Access Compliance Report Public Rights-of-Way (RR Crossings)

Intersection ID: 10025333	Main Street: E_6TH_ST	Location:	N/A
ADA ID: 6AC88C25DDDE	Overall Compliance: No	Severity Score:	0.0
Codes/Mitigation Info/Possible Solution		Field Measurements/Component Compliance

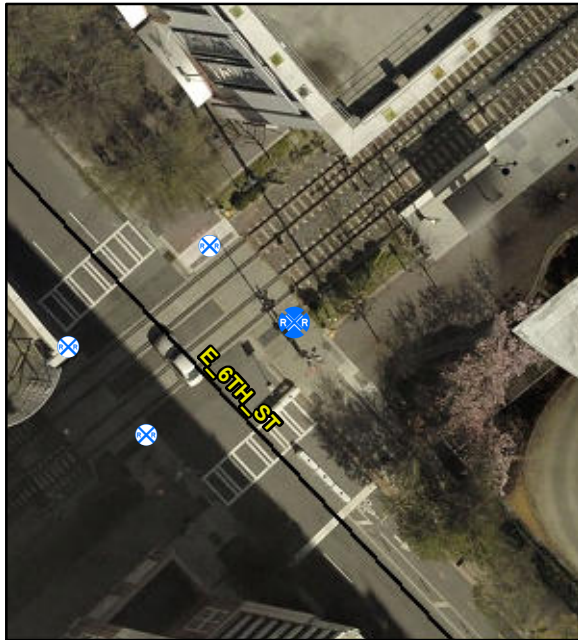
Remove & Replace Detectable Warning System. Provide Pedestrian Gate. Remove & Replace Walking Surface Adjacent to Rail.

R302.7.4, R305.1.4, R305.2.5

Compliance	Description	Data
Yes	DWS Provided?	Yes
Yes	DWS Contrast?	Yes
No	DWS Width (in)	No
Yes	DWS Length (in)	36.0
No	DWS Offset (in)	29.0
No	Pedestrian Gate?	No
N/A	DWS Outside Gate?	N/A
N/A	Rail Type?	LightRail
No	Flangeway Gap (in)	2.5
Yes	Sidewalk Width (in)	181.0
